# NOTICE OF DECISION

## PLANNING ADMINISTRATOR DECISION FOR SITE PLAN REVIEW

**CASE TYPE:** Class 2 Site Plan Review  
**AMANDA NO.:** 22-108793-RP  
**DATE OF DECISION:** September 8, 2022  
**PROPERTY LOCATION:** 3130 22<sup>nd</sup> Street SE  
**APPLICANT:** Monroe Commercial Properties, LLC  
**REPRESENTATIVE:** Ron Ped  
**ZONE:** IG (General Industrial)  
**COMPREHENSIVE PLAN:** IND (Industrial)  
**OVERLAY:** None

**PROPOSED SITE PLAN**  
SCALE : 1" = 40'-0"  
0 4' 20' 40' 80'

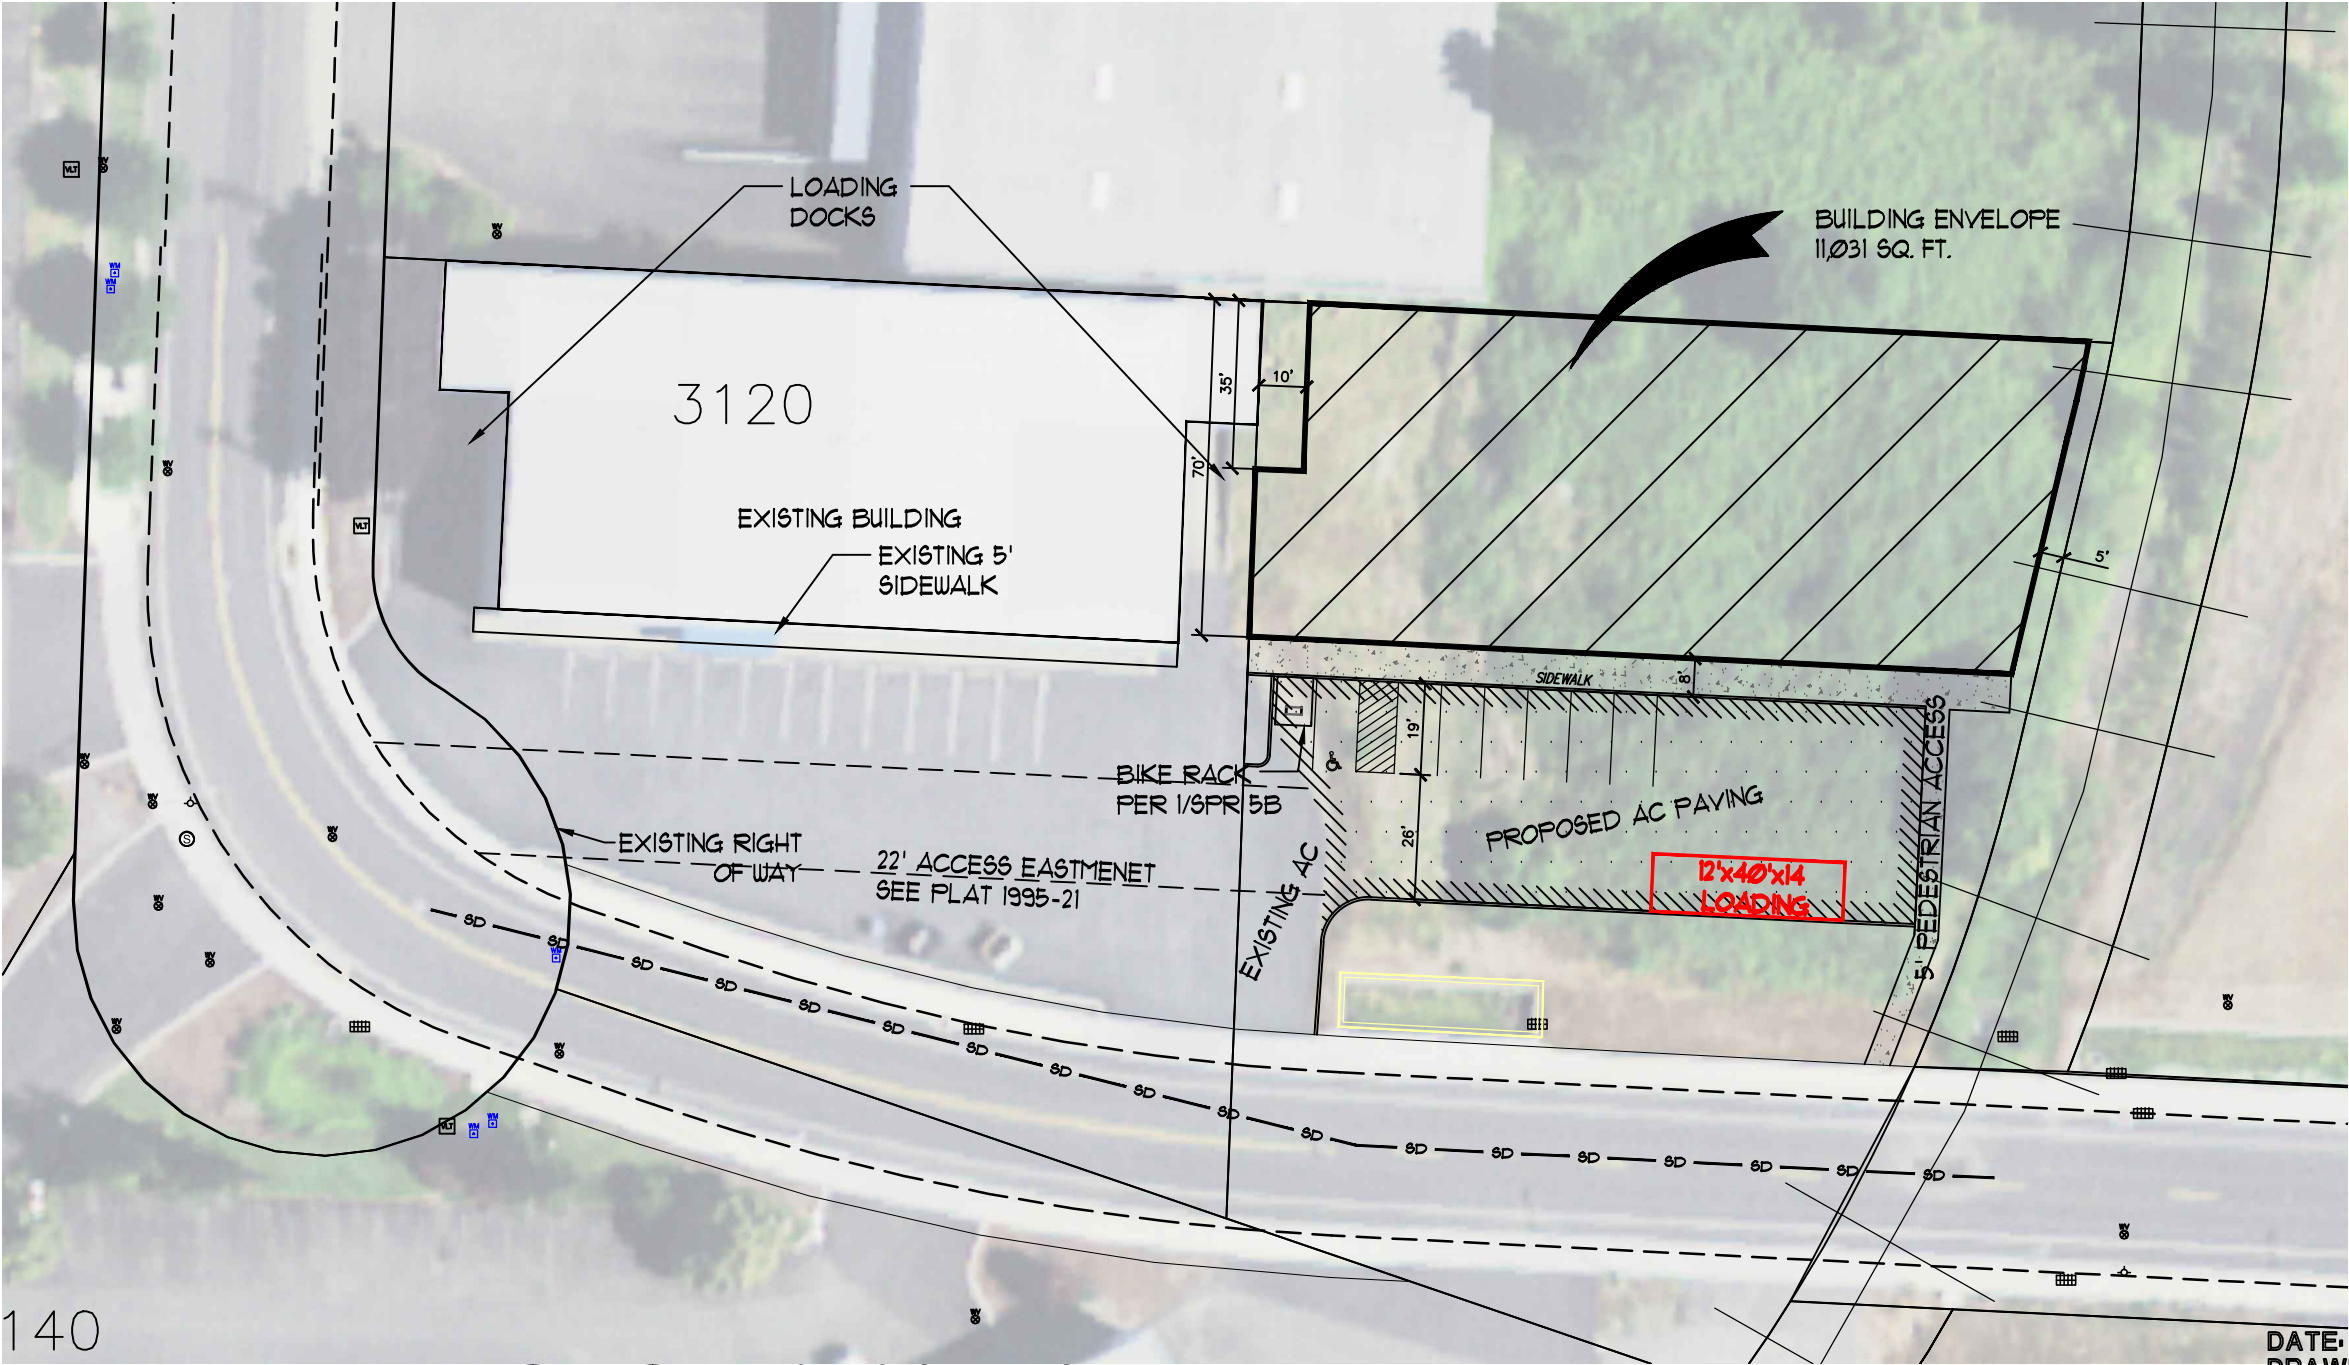
**Finding:** The applicant's site plan shows a setback of 28 feet between the proposed vehicle use area and 80-feet to the proposed structure abutting 22<sup>nd</sup> Street SE. The proposal meets the standard.

**Finding:** The site plan shows a setback of five feet between the proposed structure and the east and west property line and no setback between all other property lines. The proposed vehicle use area is setback five feet from the east and west property line. The proposal meets the standard.

**Finding:** As shown on the applicant's site plan, the proposed development satisfies the building-entrance-to-street connection requirement of SRC 800.065(a)(1) by providing a connection to 22<sup>nd</sup> Street SE. There are no existing or proposed transit stops along the development site's street frontage. The proposal meets this standard.

**Finding:** As shown on the proposed site plan, both proposed bicycle parking areas are located within 50 feet of primary building entrances. The proposal meets the standard.

The Fire Department reviewed the proposal and provided the following comment:  
*Applicant shall verify building location in relation to property lines to have the correct fire rating and openings.*
